**Proposed Rezoning from “Residential (Group B)1” Zone to “Residential (Group B)4” Zone  
for Medium-Density Housing Development to Include a Footpath for Public Use at Various  
Lots and Adjacent Government Land in DD130, Lam Tei, Tuen Mun  
– S12A Amendment of Plan Application –  
TPB Ref.: Y/TM-LTTY/11  
Further Information No. 4**

## **Response-to-Comment Table**

**Further Information No. 4**

Sample Calculation for T1\_RN02 at 13/F (63.5 mPD)  
(Daytime Scenario)

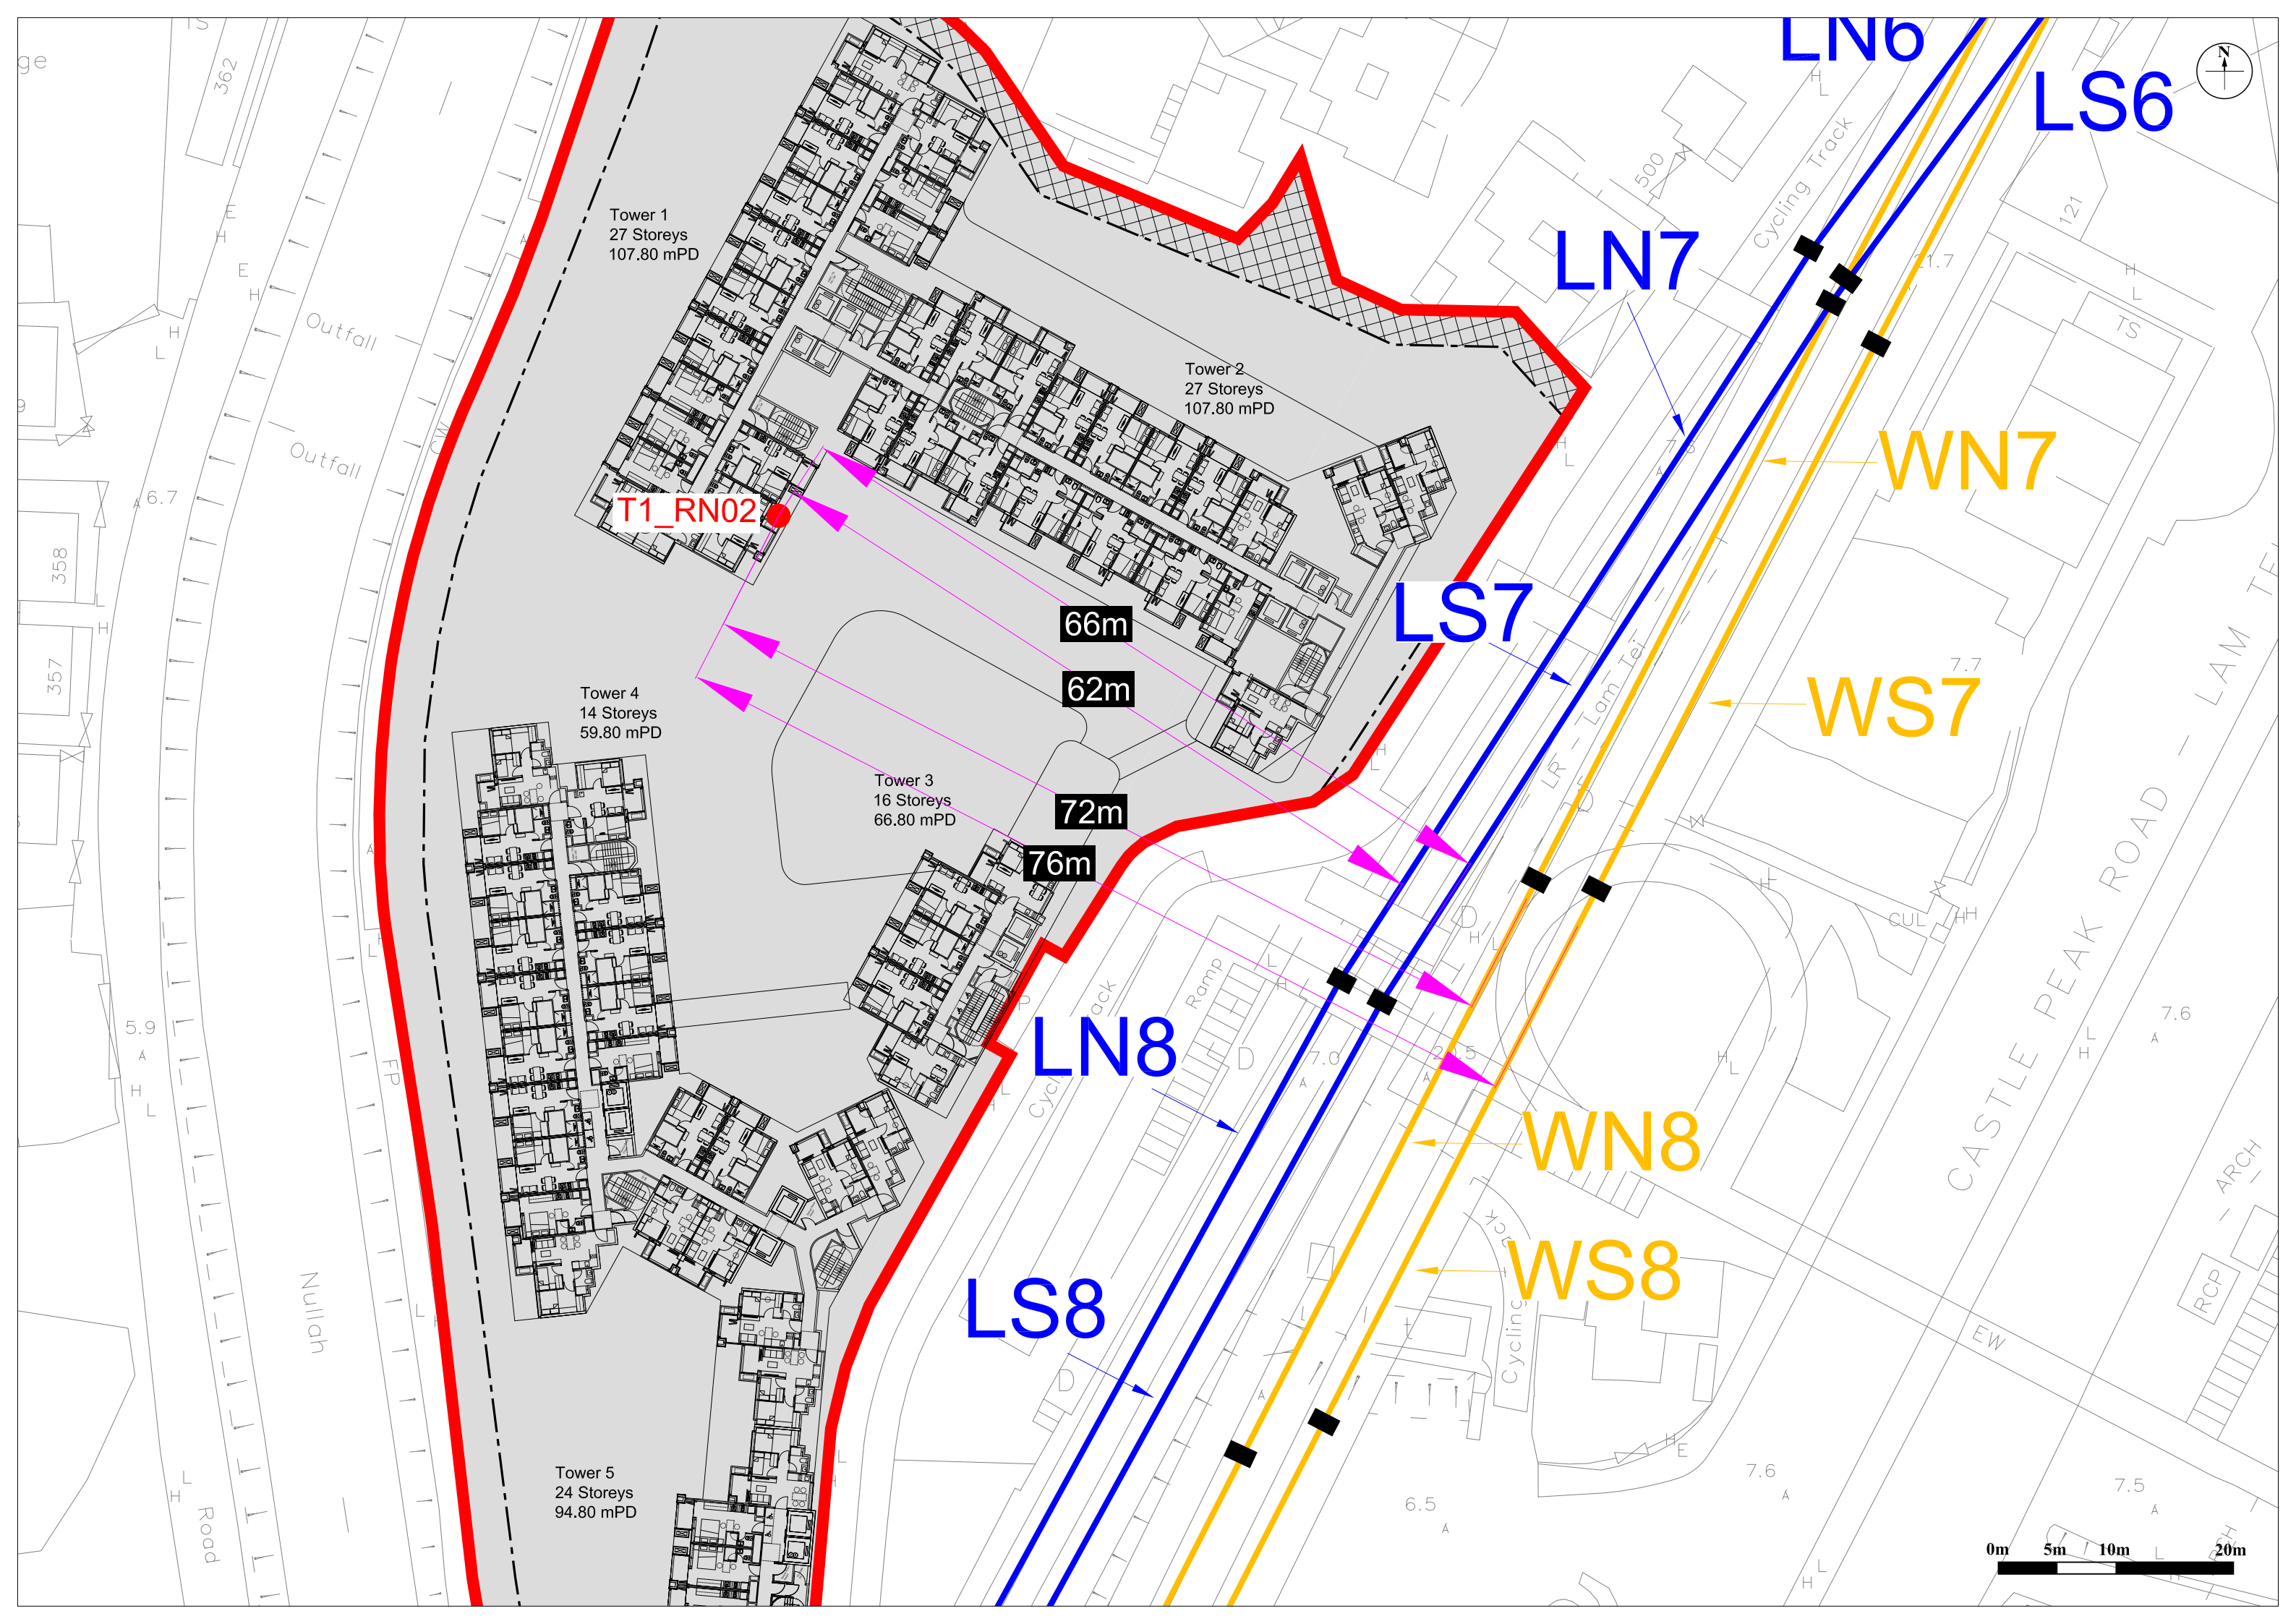
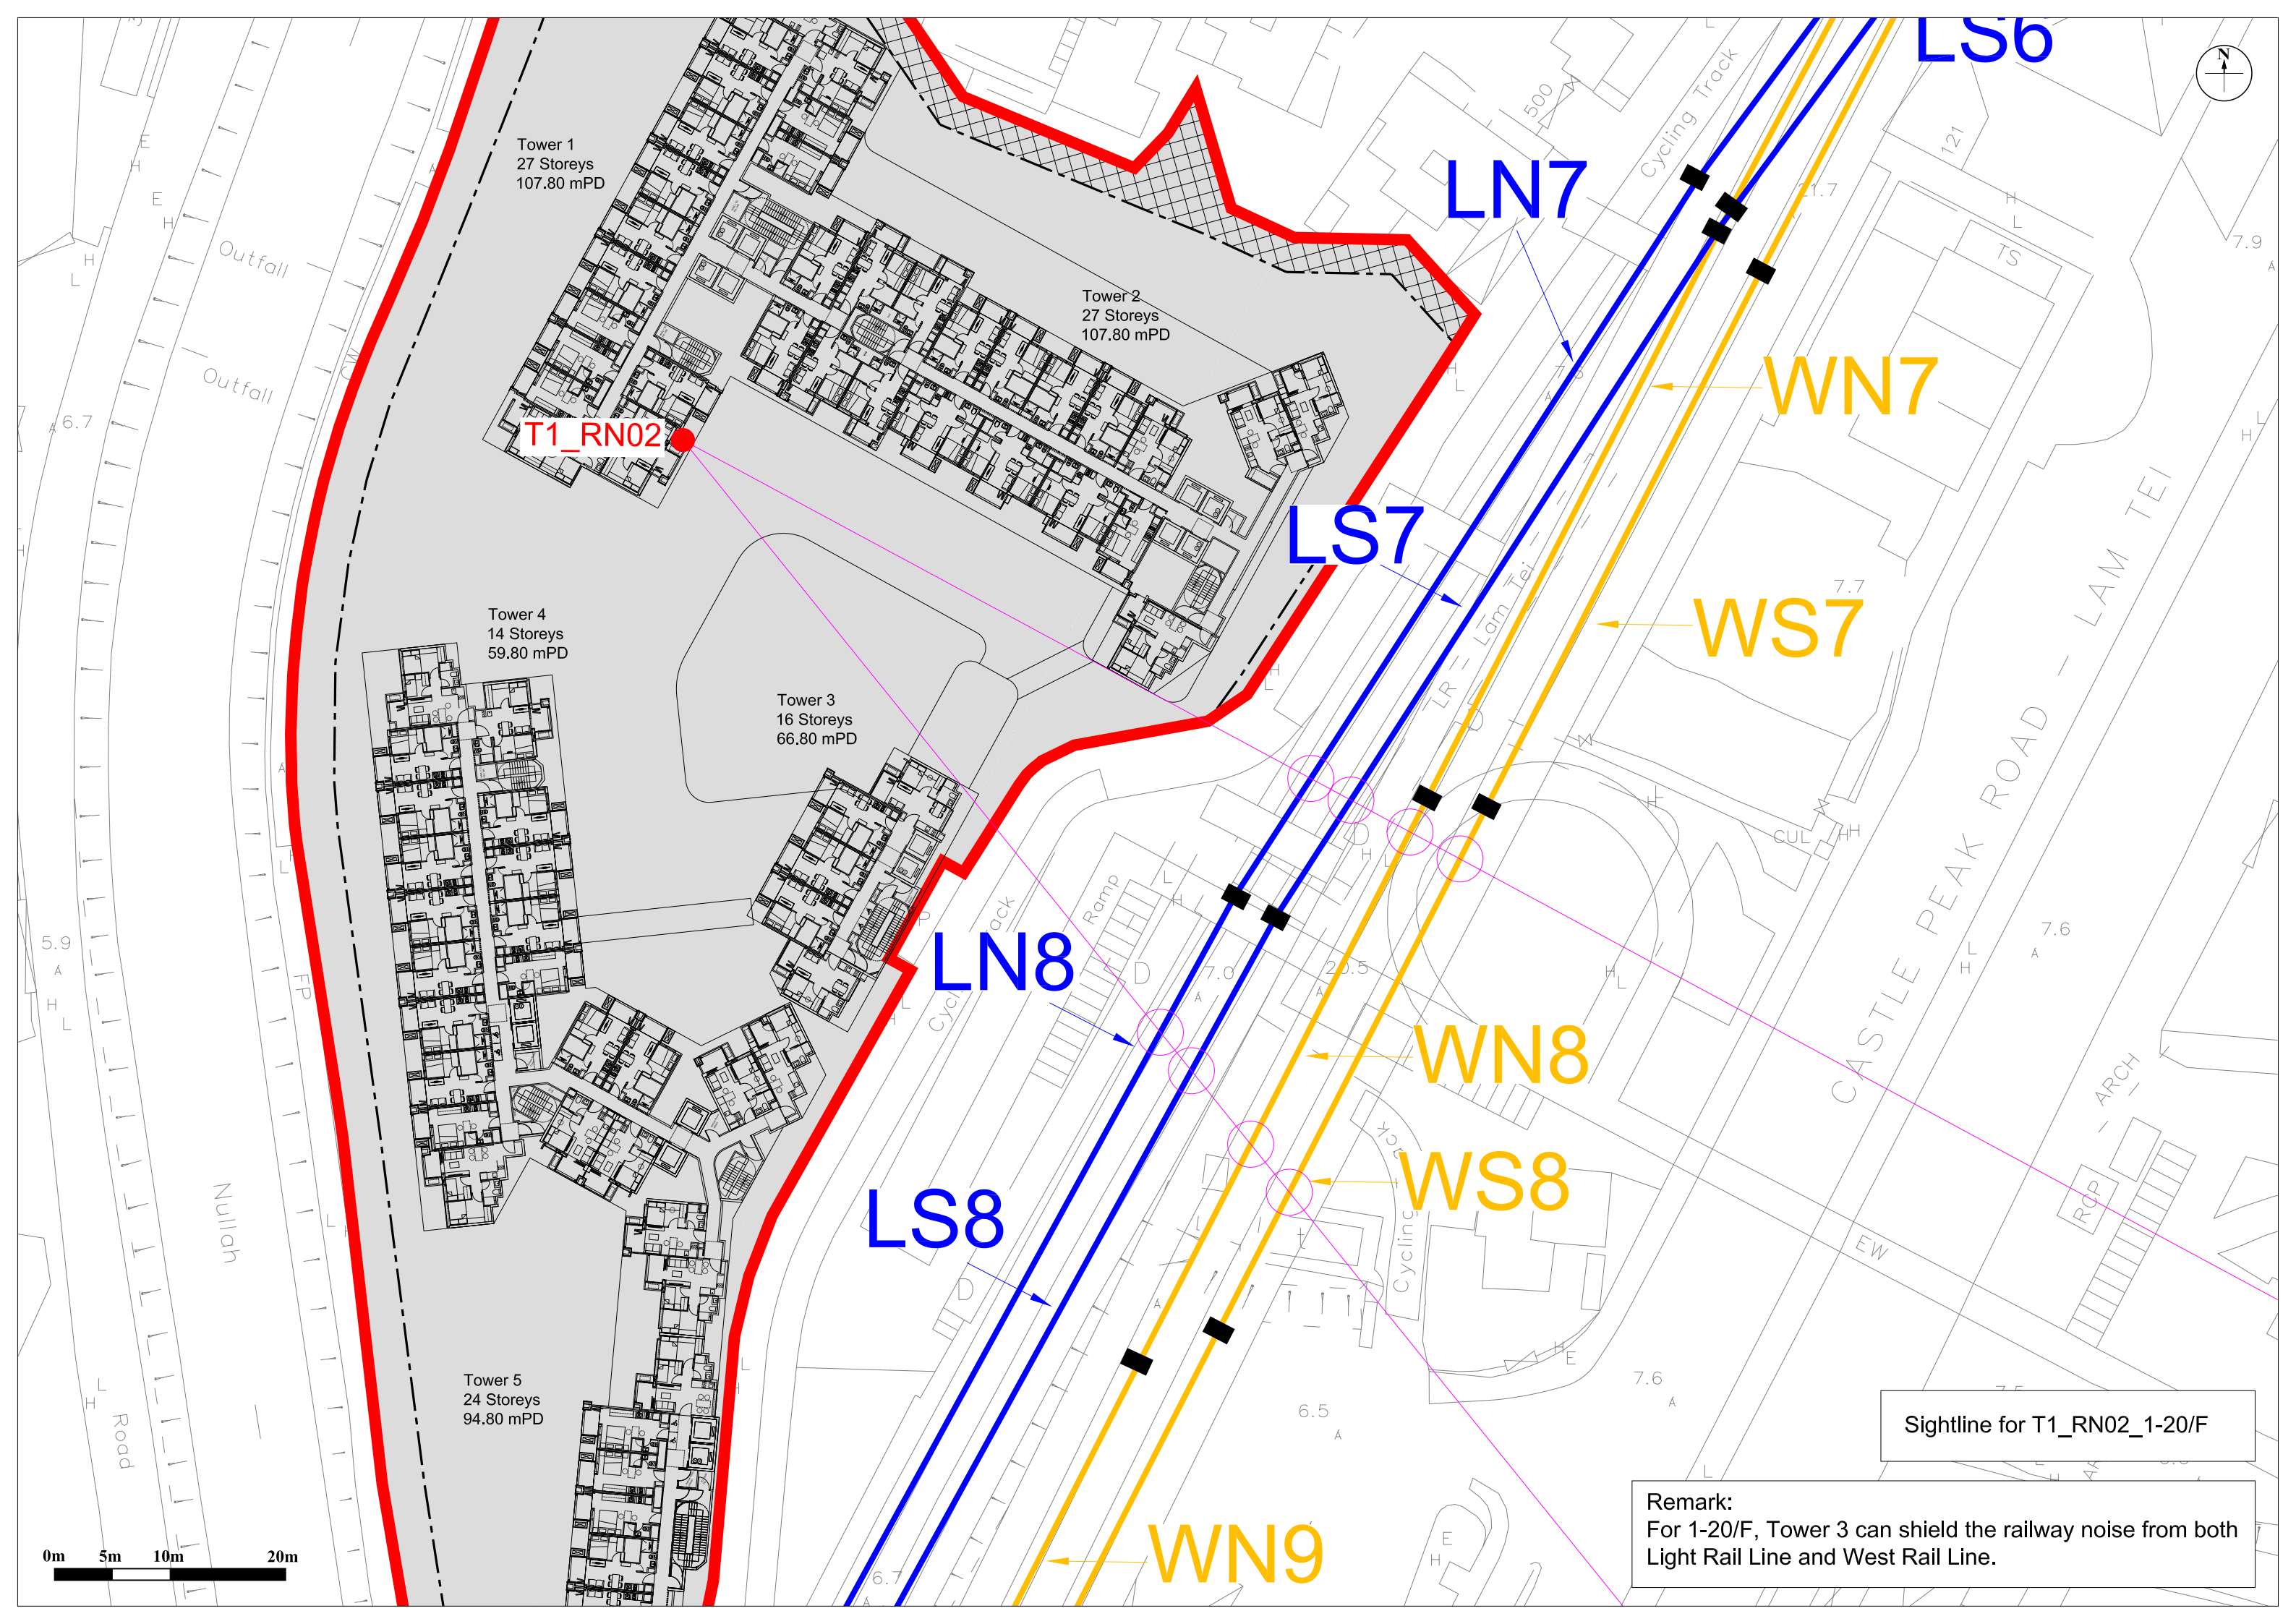
Item	Comments	Our Responses
37.	<p>The circled figure showed that solid parapet correction was applied between some NSRs and the West Rail Line Track/ Light Rail Track. Please provide more information, if there is any solid structures between the track and NSR, and it should be showed clearly in all figures (pointing out with suitable legend).</p> 	<p>The location of solid parapet and full enclosure for TML and LRT have been added to Figures 2.1 and 2.2. With reference to the information in the West Rail Operational Train Noise Assessment Report and EIA Report for Development of San Hing Road and Hong Po Road, Tuen Mun (AEIAR-227/2020), solid parapet with a height of 1.2m has been assumed for all TML segments and some LRT segments within the assessment area.</p>
